PA2503984 – 101-133
Maidstone Street, Altona –
Mt St. Joseph Girls School

Officer Assessment Report
Development Approvals & Design

Department
of Transport
and Planning

Figure 16: Setback from southern property boundary

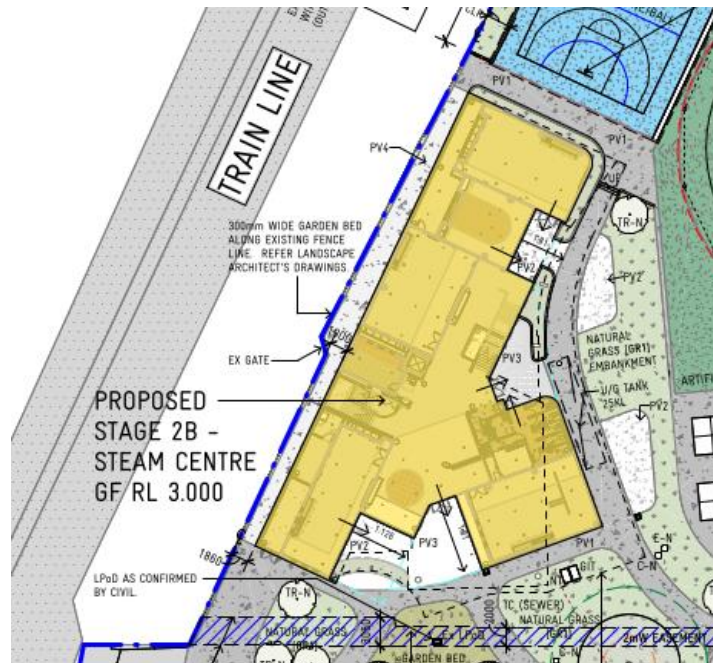
49. The proposed school building is set back 1.9m from the property boundary adjacent to the railway line. The three storey STEAM building has a maximum building height of 14.3m and is located within the school site along the southern boundary.

Figure 17: Southern elevation STEAM Building

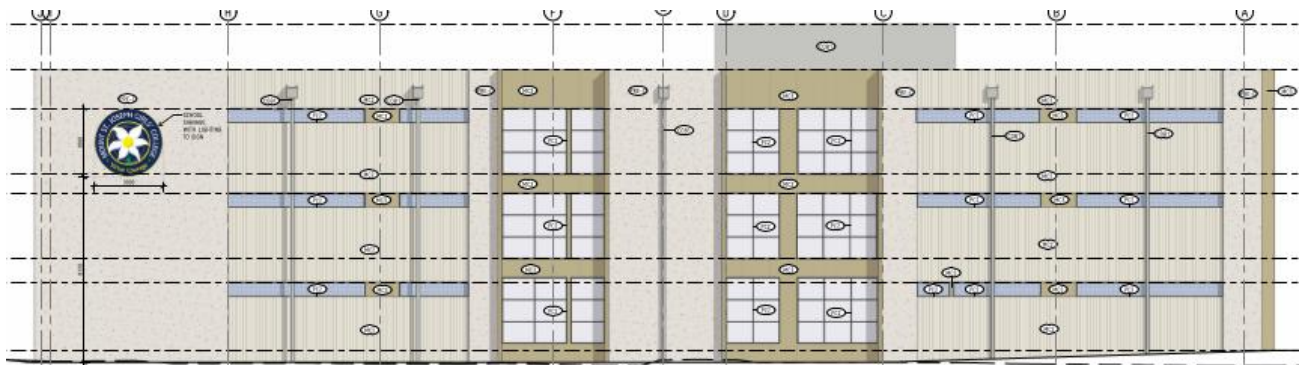
50. The STEAM Building learning hub three substantial maintenance sheds and extensive hard surfacing in this location.
51. The new building is proposed to be sited within close proximity to existing double storey school buildings including the Byrne Learning Centre and Library. These buildings already set a precedent for a more intense built form along the southern boundary.
